# HISTORIC AND DESIGN REVIEW COMMISSION

**HDRC CASE NO:** 2021-273  
**ADDRESS:** 1038 DAWSON ST  
1042 DAWSON ST  
1046 DAWSON ST  
1050 DAWSON ST  
**LEGAL DESCRIPTION:** NCB 1371 (AMINI SUBD), BLOCK 3 LOT 40  
**ZONING:** RM-4, H  
**CITY COUNCIL DIST.:** 2  
**DISTRICT:** Dignowity Hill Historic District  
**APPLICANT:** ricardo mccullough  
**OWNER:** ALLY AMINI/OMA DEVELOPERS LLC  
**TYPE OF WORK:** Construction of two, 1-story residential structures and two, 2-story residential structures  
**APPLICATION RECEIVED:** June 01, 2021  
**60-DAY REVIEW:** Not applicable due to City Council Emergency Orders  
**CASE MANAGER:** Edward Hall  
**REQUEST:**

The applicant is requesting a Certificate of Appropriateness for approval to construct two, 1-story residential structures and two, 2-story residential structures on the vacant lots at 1038, 1042, 1046, and 1050 Dawson Street, located within the Dignowity Hill Historic District.

**Historic and Design Review Commission**  
***Design Review Committee Report***

STREET SCAPE

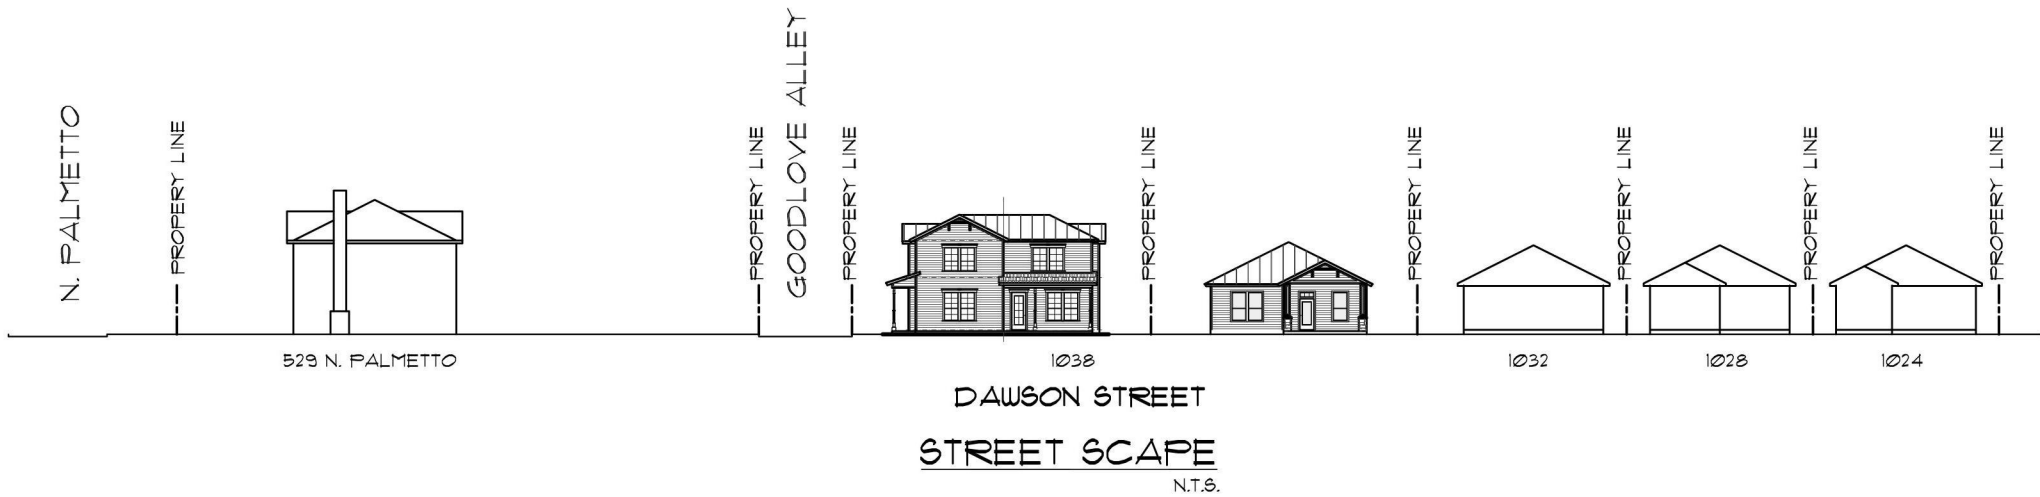
MS: Could the topography been shown in the street elevation?

A/C LOCATION

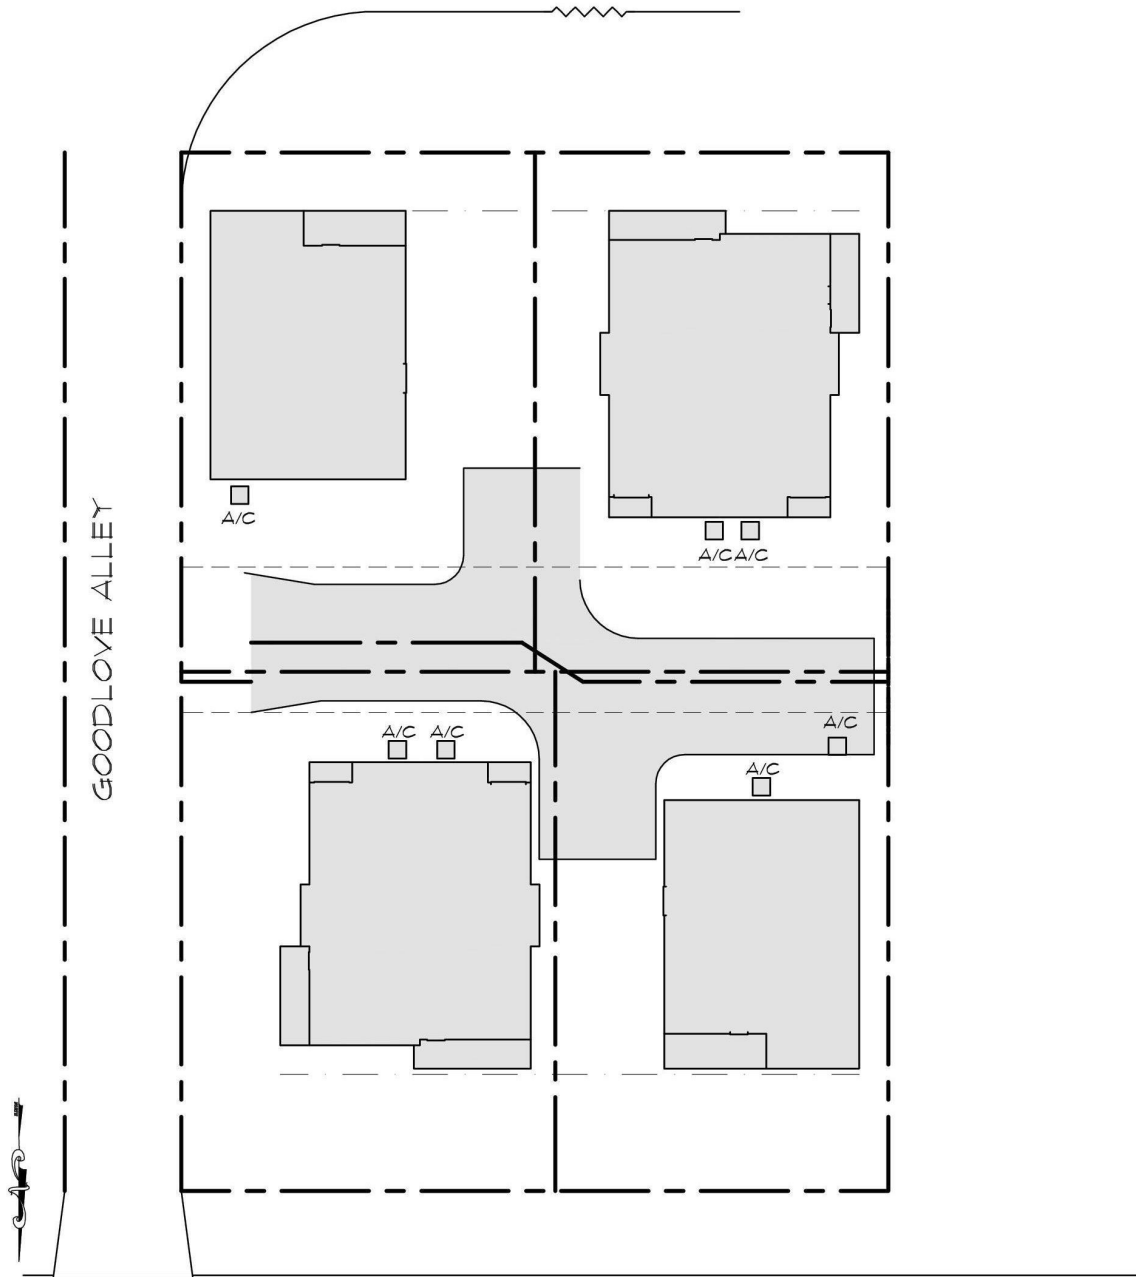
- v. MECHANICAL EQUIPMENT – The applicant has noted the locations of mechanical equipment at the rear each structure; however, has not noted if the mechanical equipment will be screened. All mechanical equipment should be screened from view at the public right of way with screening elements.

- iv. That all mechanical equipment be screened from view as noted in finding v.
- v. That only one walkway lead from the front porch to the right of way for each duplex structure, as noted in finding u.

PORCH DEPTH

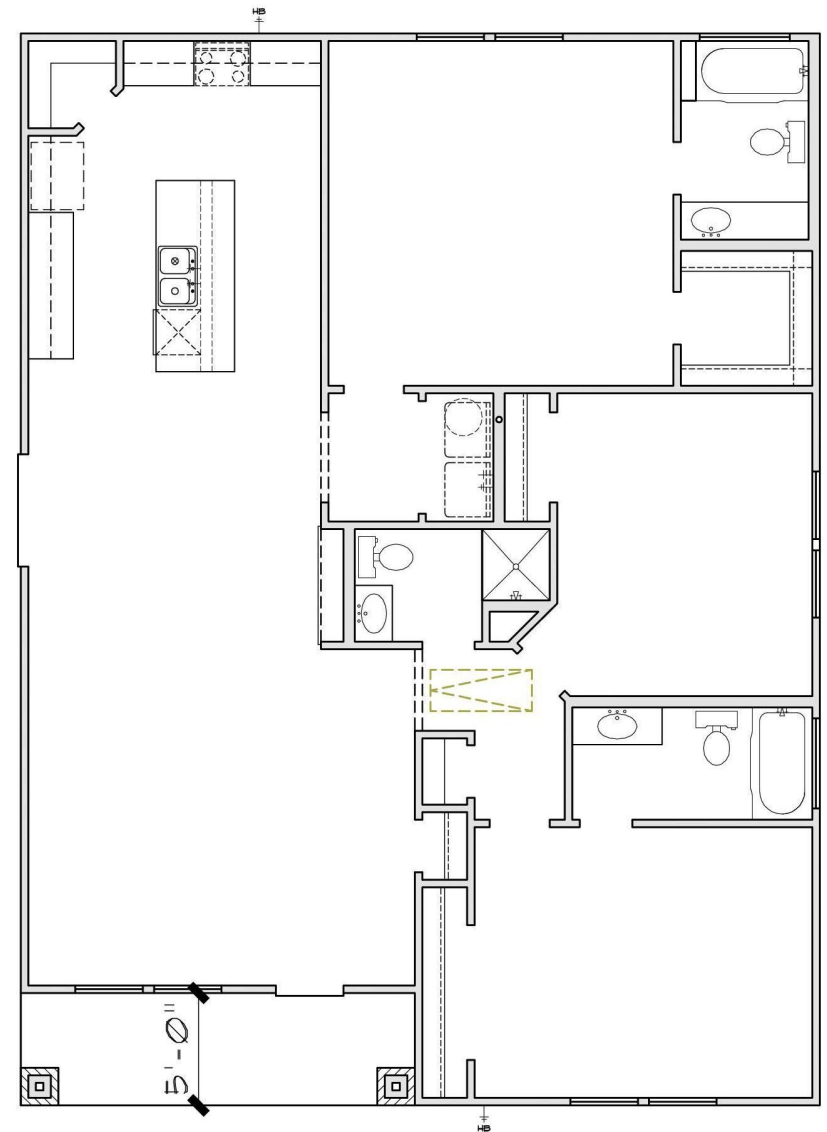
- m. PORCHES – The applicant has proposed for the two, 1-story structures to feature porches that are integral to the massing of the house. For the two, 2-story structures, the applicant has incorporated both a front and side porch; however, both porches feature minimal insets; approximately one (1) foot within the massing of the structure. Typically, within the historic district, both side and front porches feature depths of at least five (5) feet within the massing of the structure.

- i. That all foundation heights follow the guidelines and feature at least one foot in height, as noted in finding j.
- ii. That each structure feature a front porch with massing that is integral to that of the proposed new construction. Staff recommends front porch depths of approximately five (5) feet, as noted in finding m.

FOUNDATION

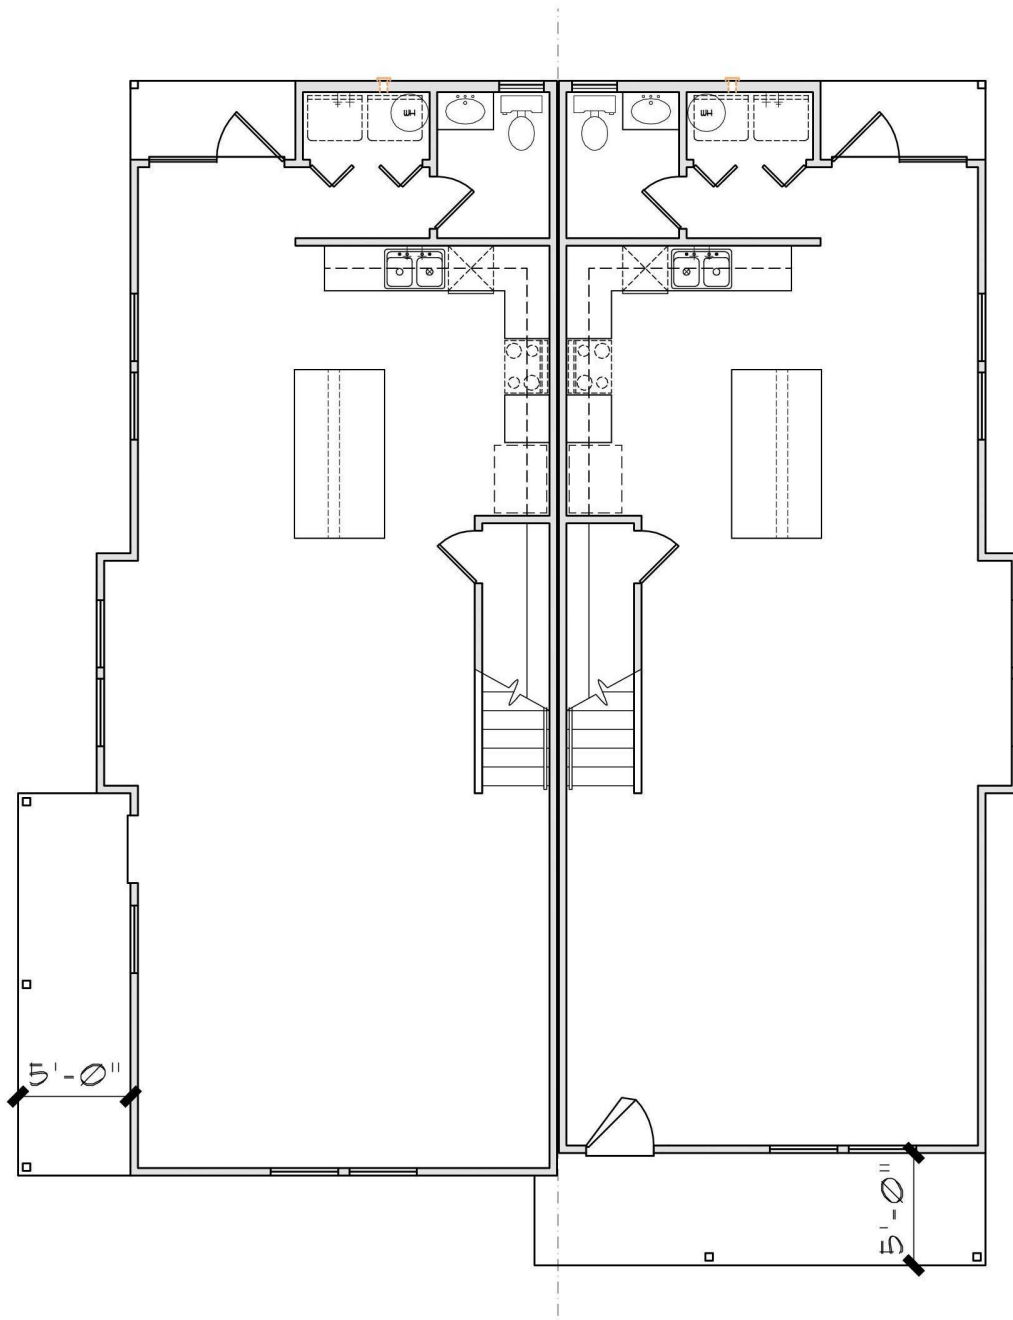
- j. FOUNDATION & FLOOR HEIGHTS – Per the Guidelines for New Construction 2.A.iii., applicants should align foundation and floor-to-floor heights within one foot of floor-to-floor heights on adjacent historic structures. Per the submitted construction documents, the applicant has proposed foundation heights that appear to be at least 1 (one) foot in height; however, staff finds that the applicant should confirm the proposed foundation heights for each structure.
